Lower Thames Crossing

10.4 Change Application (August 2023)

Planning Inspectorate Scheme Ref: TR010032
Examination Document Ref: TR010032/EXAM/10.4

Plate 6.4 Revised East Tilbury land use resulting from proposed change

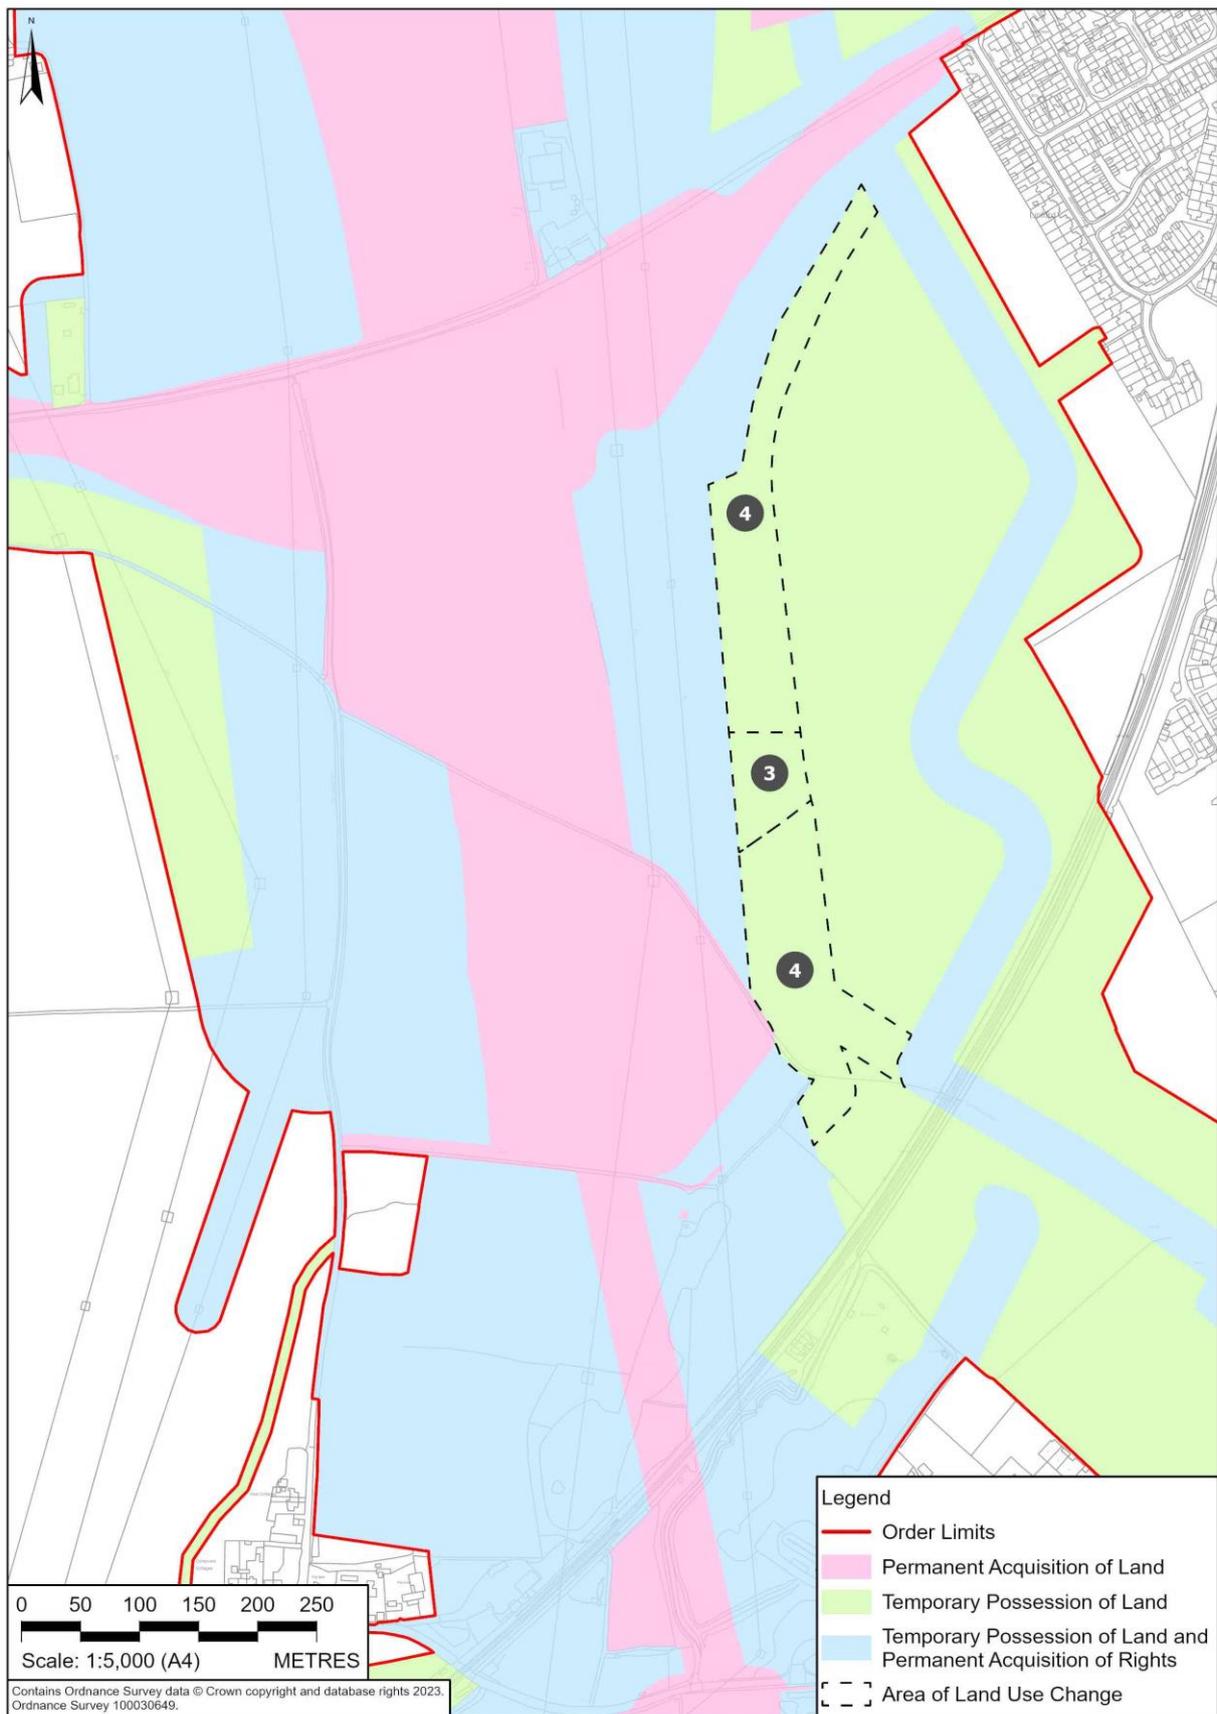
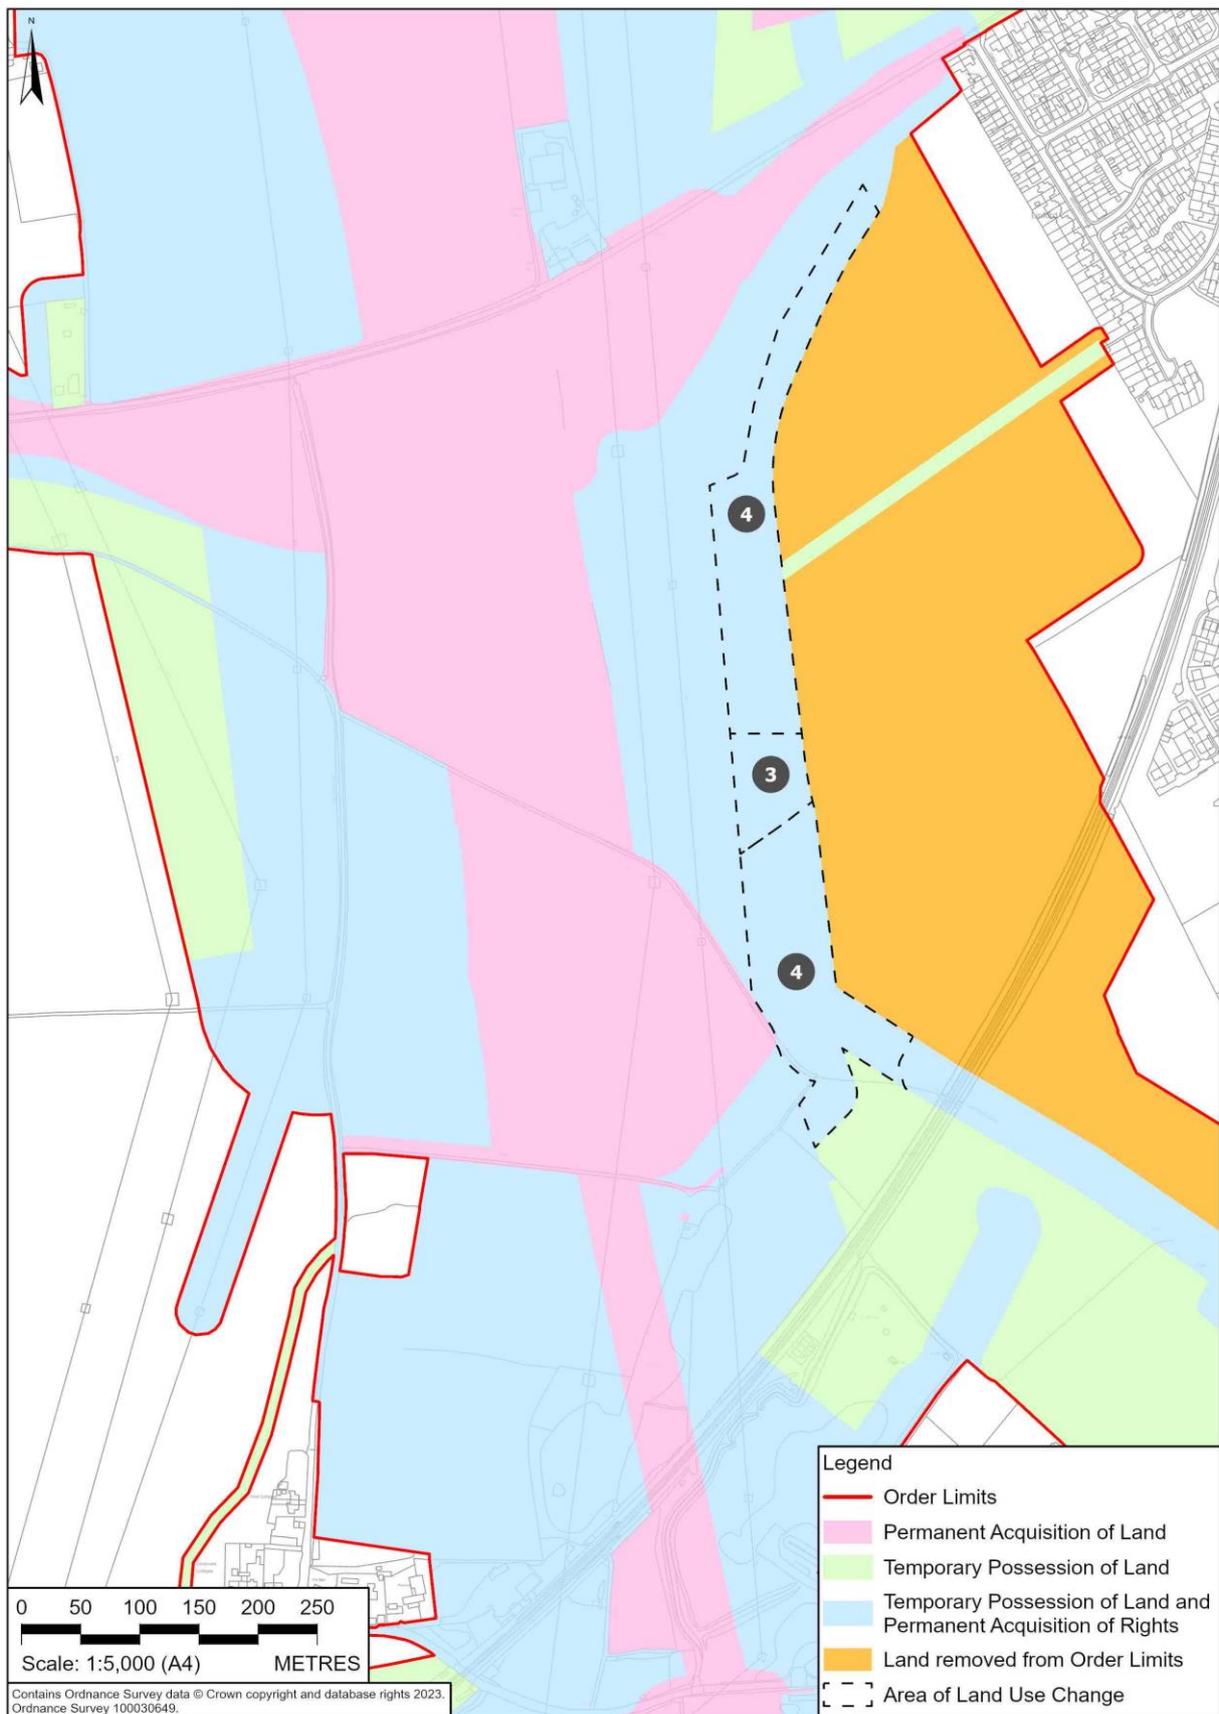
- 6.1.1 During ongoing landowner engagement, the Applicant identified that there was an opportunity to make modifications to the proposed temporary works in the Tilbury area. By changing the location of the two Utility Logistics Hubs and modifying the alignment of the temporary Linford bore pipeline, it would be possible to reduce the temporary land requirements in the area, reducing the Order Limits and impacts on land as a result. This change would also move construction works further away from residential properties in East Tilbury, reducing the potential environmental impacts associated with those works.
